ATTACHMENT I
TO
JPN-88-003

PROPOSED TECHNICAL SPECIFICATION CHANGES
RELATED TO
MANAGEMENT REORGANIZATION OF THE
NEW YORK POWER AUTHORITY
(JPTS-88-004)

NEW YORK POWER AUTHORITY
JAMES A. FITZPATRICK NUCLEAR POWER PLANT
DOCKET NO. 50-333
DPR-59

SAFETY EVALUATION OF
PROPOSED TECHNICAL SPECIFICATIONS
RELATED TO
MANAGEMENT REORGANIZATION OF THE
NEW YORK POWER AUTHORITY
(JPTS-88-004)

FIGURE 6.1-1

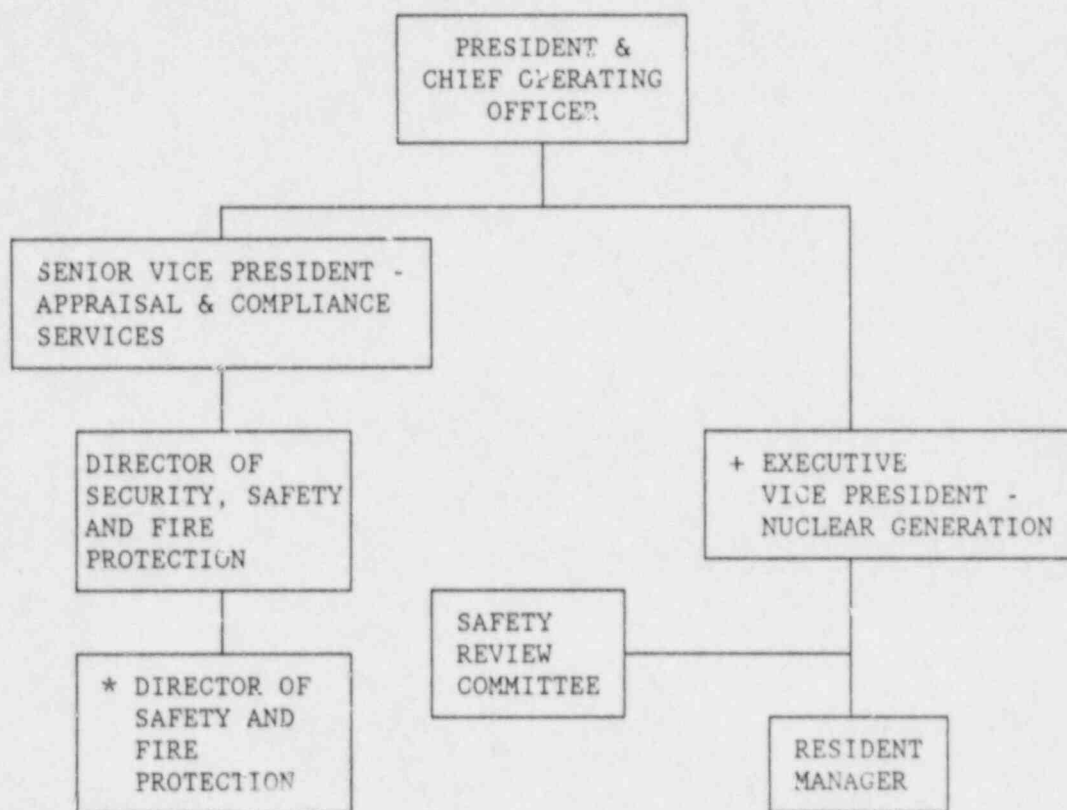
Specifically, the following changes are proposed for Figure 6.1-1 on page 259 of Appendix A entitled , "Management Organization Chart".

- [a] The Engineering and Design Department has been eliminated. Accordingly, the position of Executive Vice President & Chief Engineer-Engineering and Design has been eliminated.
- [b] The position of First Executive Vice President-Operations has been eliminated.
